**PARK CITY MUNICIPAL CORPORATION  
HISTORIC PRESERVATION BOARD**  
COUNCIL CHAMBERS, CITY HALL  
March 20, 2013

505 Woodside Avenue – Appeal of Historic District Design Review

## Historic Preservation Board Staff Report

**Subject:** 505 Woodside Avenue  
**Author:** Kirsten A. Whetstone, MS, AICP  
**Project #:** PL-13-01842  
**Date:** March 20, 2013  
**Type of Item:** Quasi-Judicial Appeal

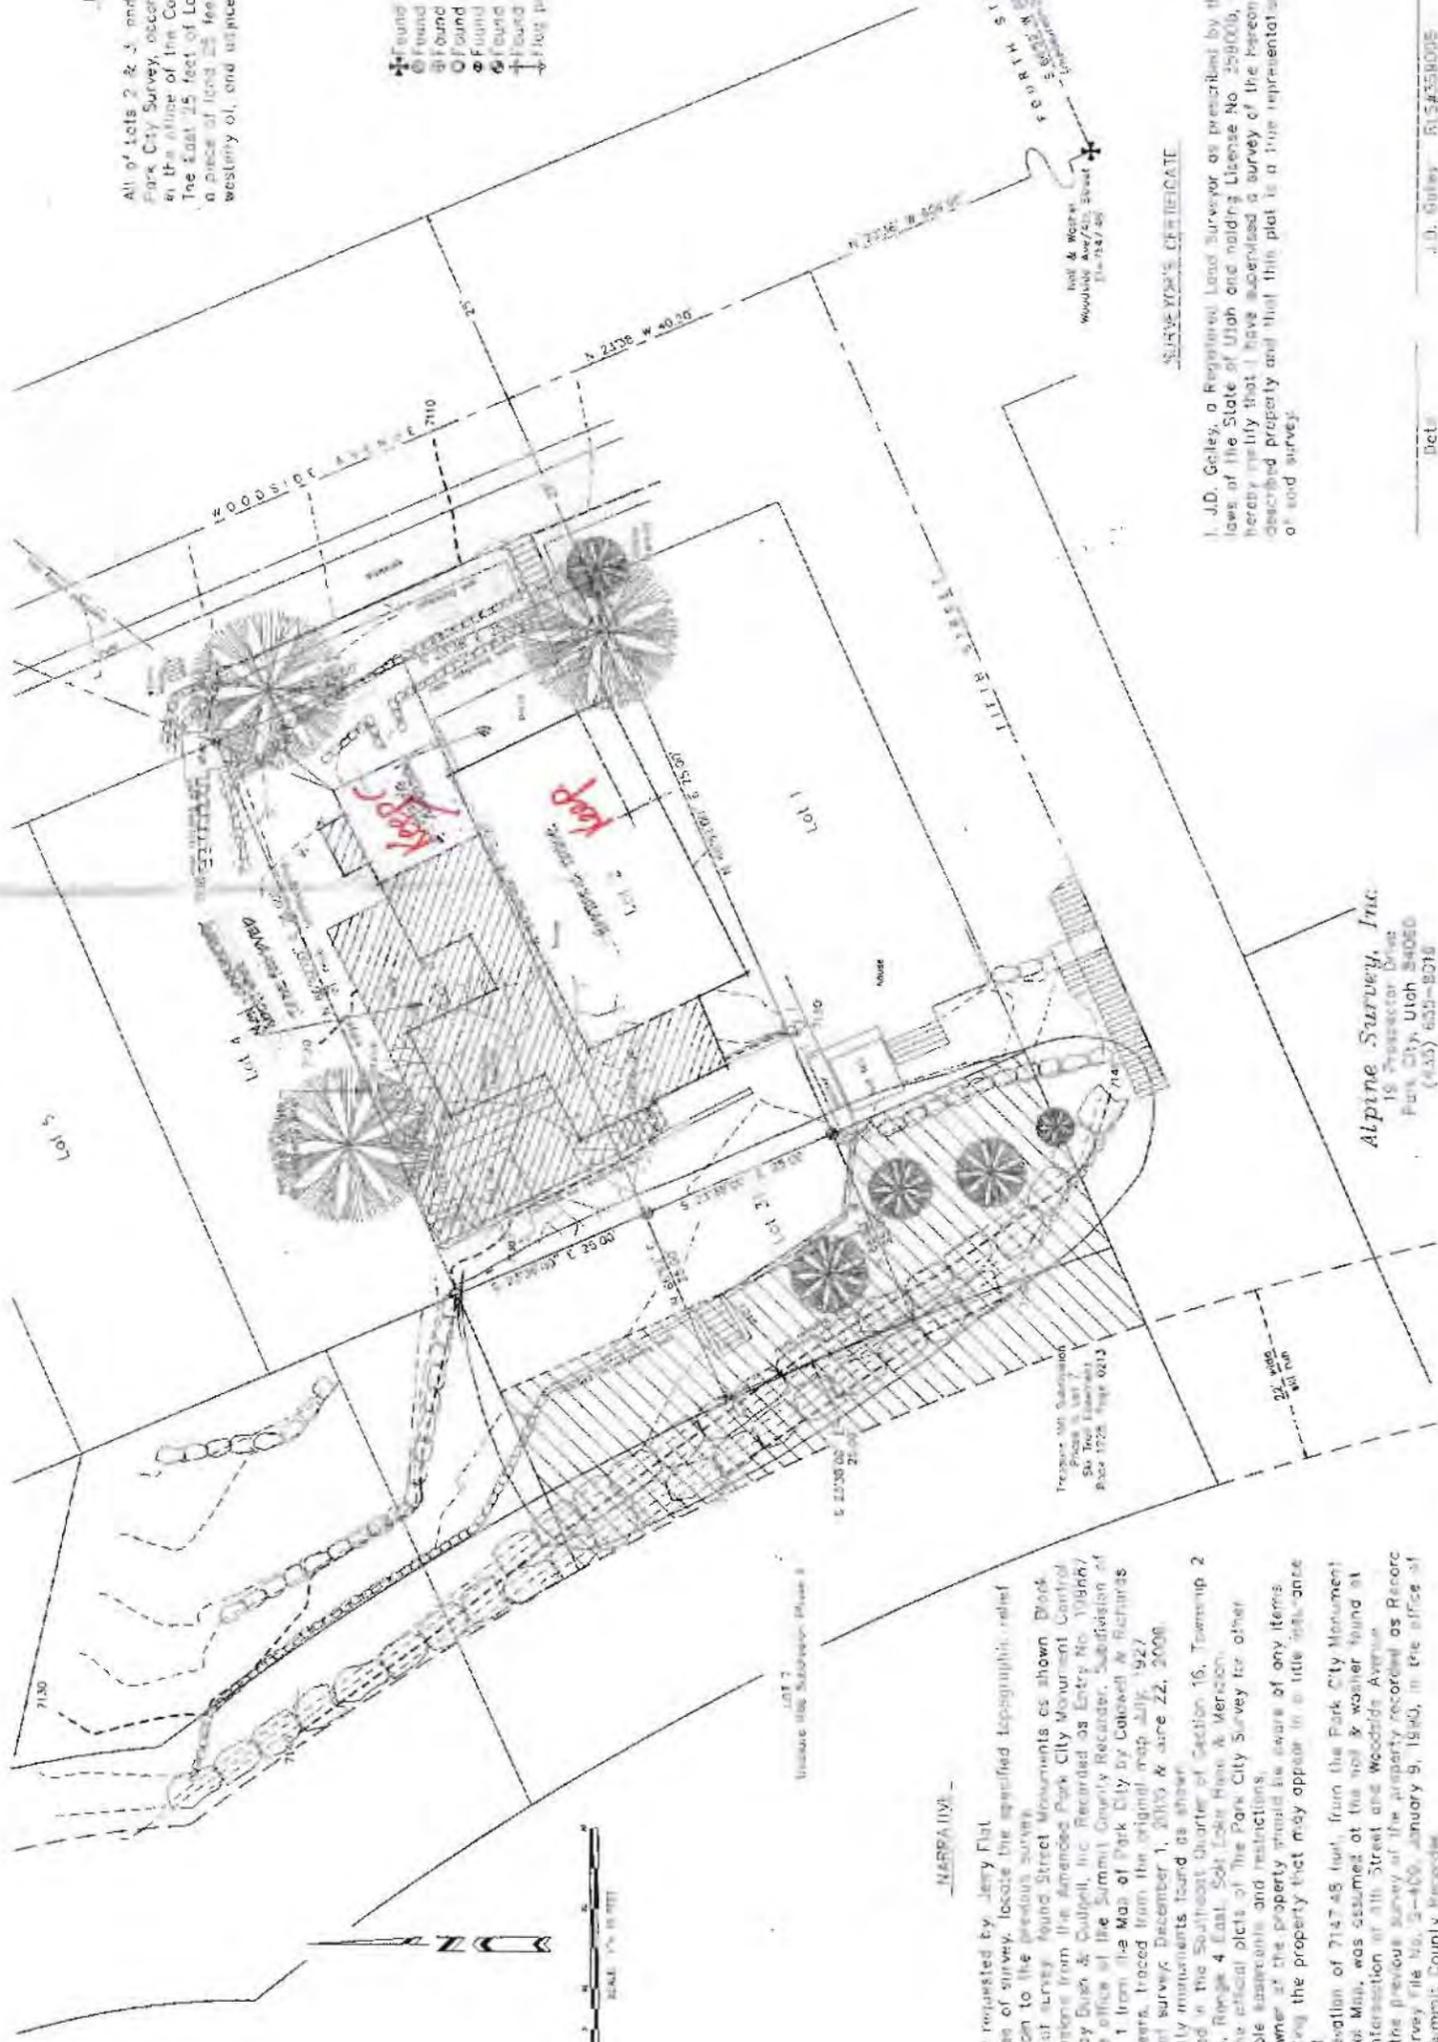
#### ***1. The HDDR Application was Incomplete. (Site plan contains inadequate topographic contours and misstated spot elevations.)***

The topographic survey submitted was prepared and certified by a licensed surveyor. (See Exhibit B) There are 2’ contour intervals on the survey. In certain instances, such as on an existing retaining wall that is 4’ or 6’ tall, 2 or 3 of the two foot intervals fall on top of each other in plan view. Additionally, there is not a

Staff analysis: The HDDR Application was deemed complete on September 24, 2012 as all required submittal items were provided with the application including both a topographic survey and a preservation plan.

**EXHIBIT 6**

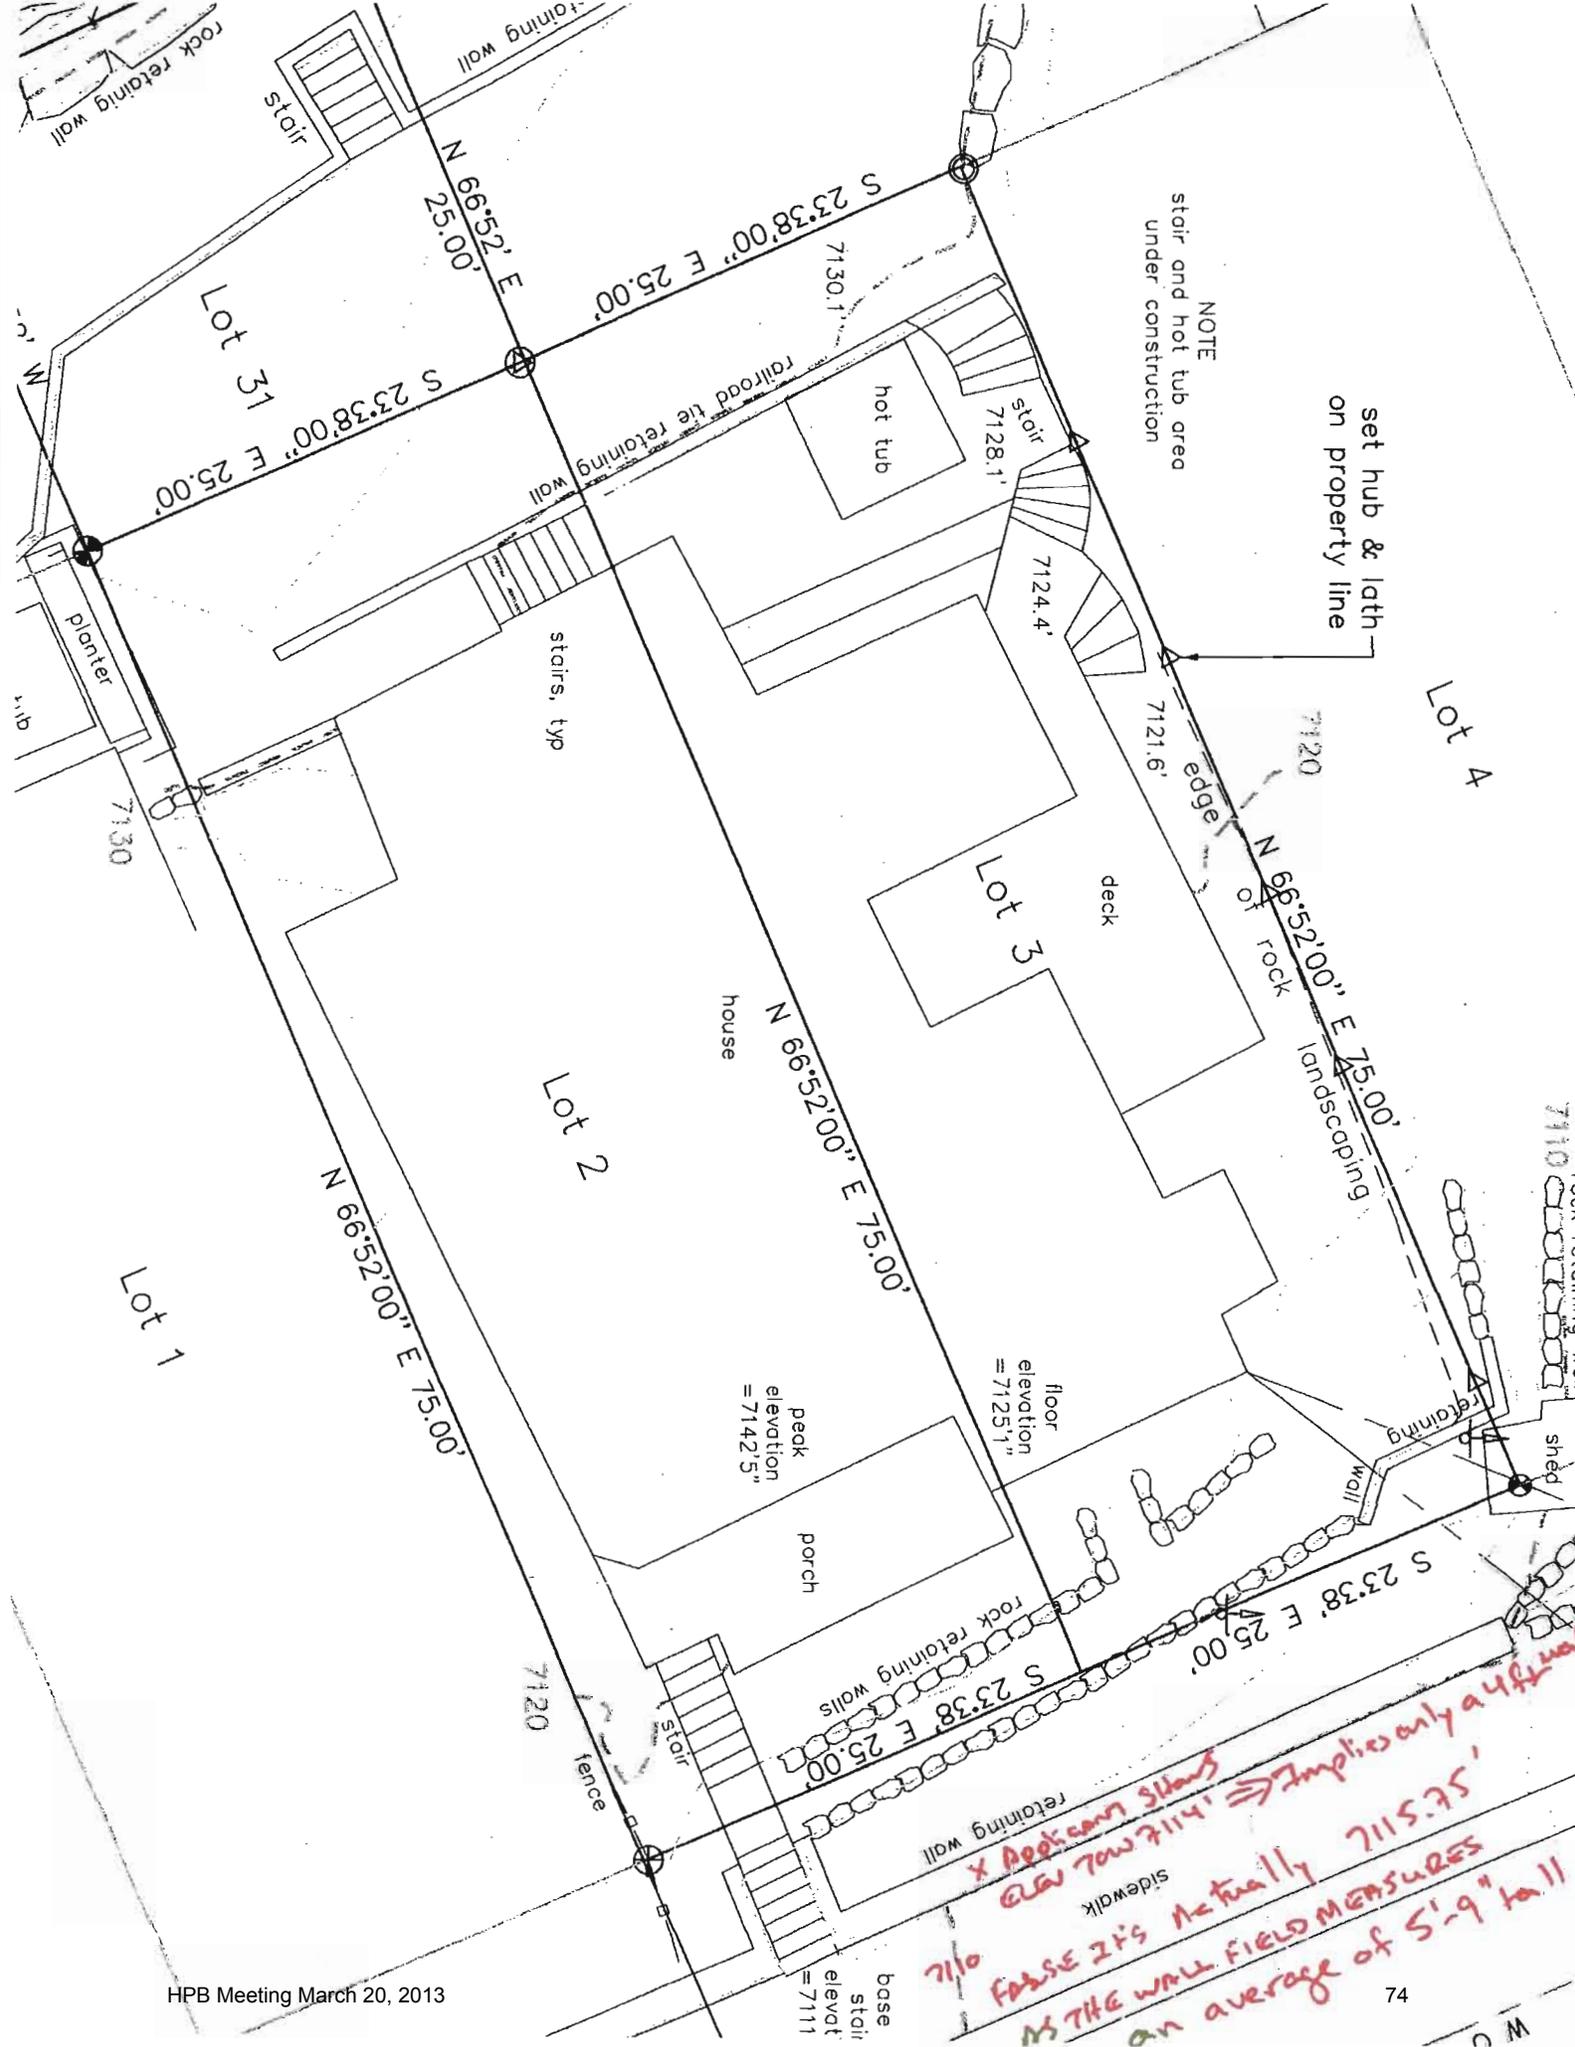
The Appellant has field measured that existing poured concrete wall located in the Front Yard/City ROW and it has an average height of 5'-9" approvals, which would make the actual height of the wall 7115.75', or 1.75' higher than the elevation that applicant represents in his Site Plan. Furthermore, not only does the applicant not depict the need for 6 ft walls in the front yard he also not depict or disclose the need for the 6ft - 8ft retaining walls necessary to retain the earth along the sides of the driveway (Exhibit 11). Nor is then any cross-sections or engineering details on how said walls will actually be constructed. Therefore, the these over height walls in the front yard will require an Engineering approval, Planning Director approval and an Administrative CUP in accordance with LMC 15-4-2(A) (Exhibit 12).

*X Appleton shows  
 also 70w 7114  
 FALSE IT'S ACTUALLY 7115.75'  
 AS THE WALL FIELD MEASURES  
 AN AVERAGE OF 5'-9" TO 11"*

**EXHIBIT 11**

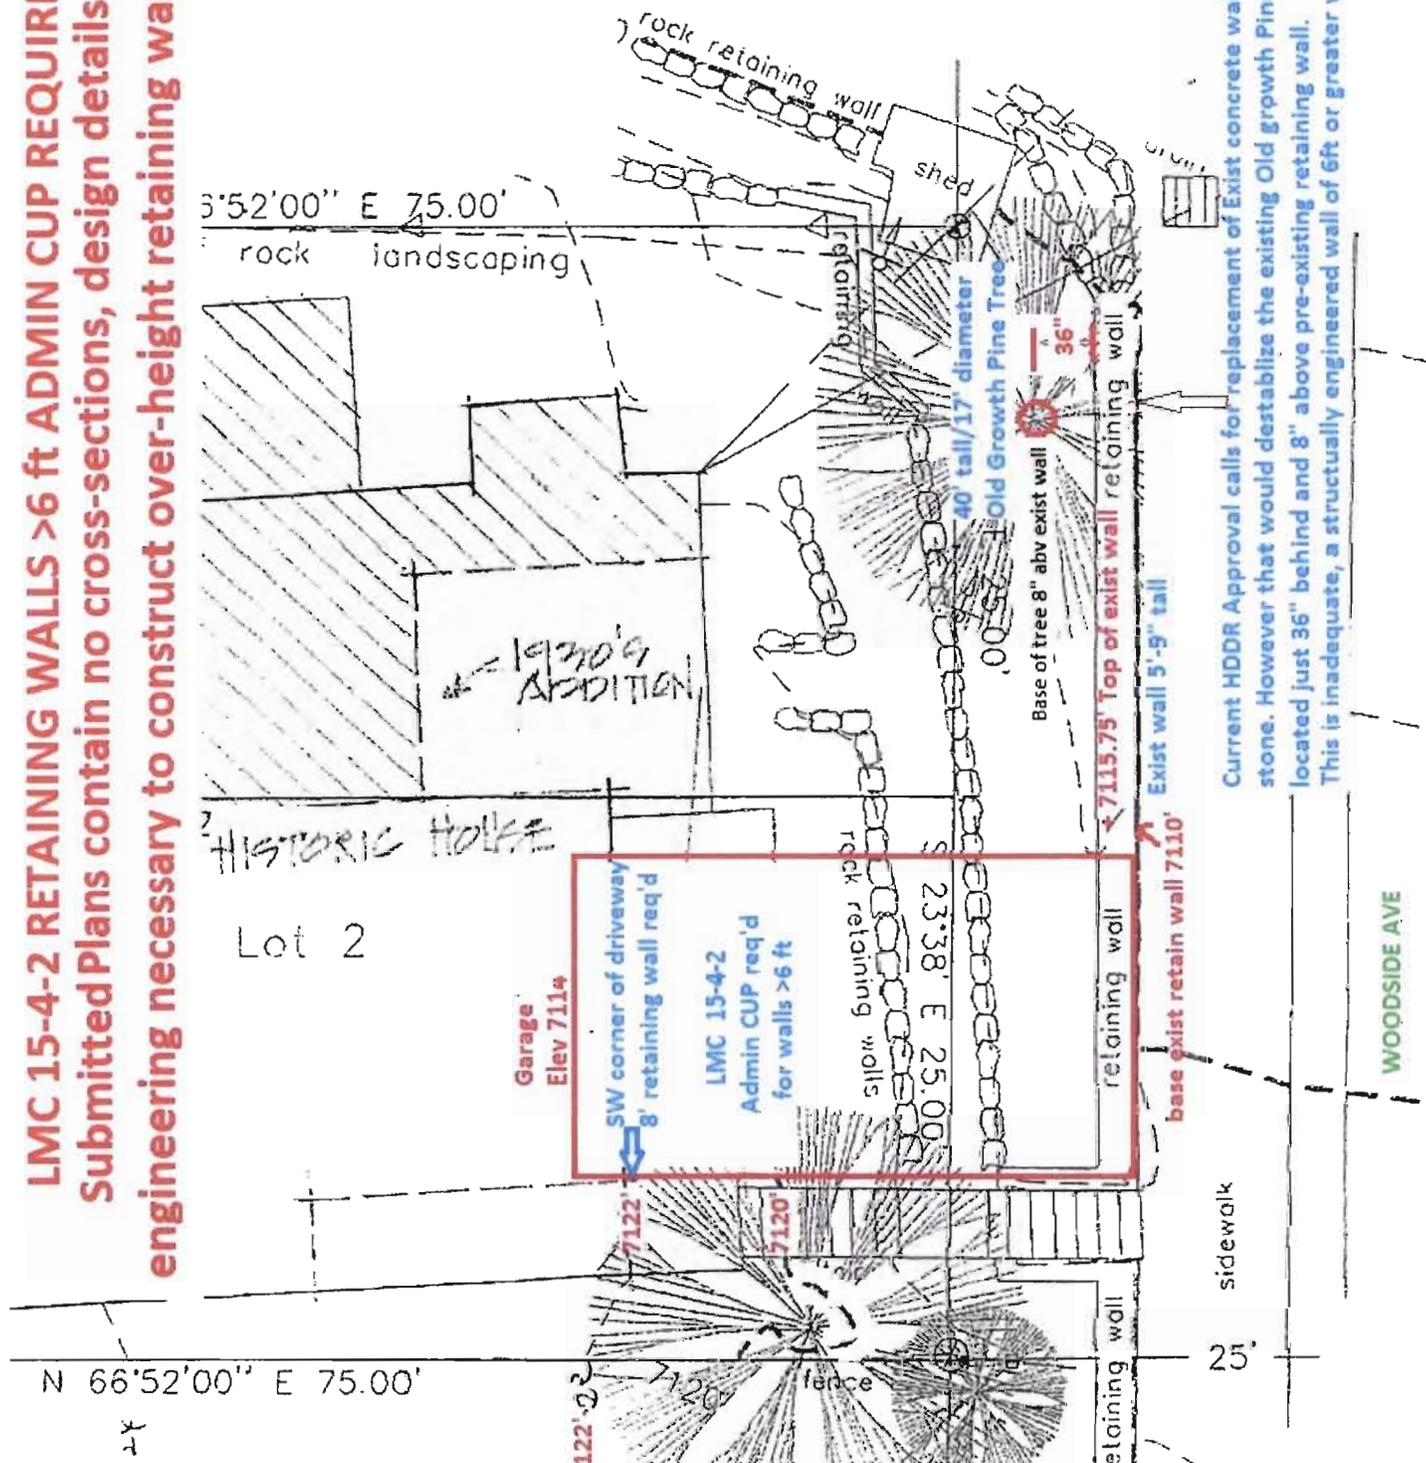
**LMC 15-4-2 RETAINING WALLS >6 ft ADMIN CUP REQUIRED  
Submitted Plans contain no cross-sections, design details or  
engineering necessary to construct over-height retaining walls.**

Current HDDR Approval calls for replacement of Exist concrete wall with dry stack stone. However that would destabilize the existing Old growth Pine in city ROW located just 36" behind and 8" above pre-existing retaining wall. This is inadequate, a structurally engineered wall of 6ft or greater will be required.

Likewise, Appellant makes certain arguments regarding the height of the walls as depicted in the survey (first paragraph of Argument 2 (sic – labeled 2, really 3)). Although retaining walls greater than 4' in height, located in the front setback area, require a building permit and Planning Director/Building Official approval and retaining walls greater than 6' in height in the front, side or rear yards also require an administrative conditional use permit and a building permit, the current HDDR approval includes a note on the plans that all stone retaining walls on the property will be dry-hand stacked 2' to 4' high walls (non-engineered walls, therefore less than 4' in height). These low stacked walls do not require a building permit or a Conditional Use Permit.

- a) Add "retaining walls" to the list of items in Condition of Approval #10 to be reviewed by the City Engineer at the time of building permit plan review.
- b) Add a condition of approval that all retaining walls shall comply with the Land Management Code requirements.
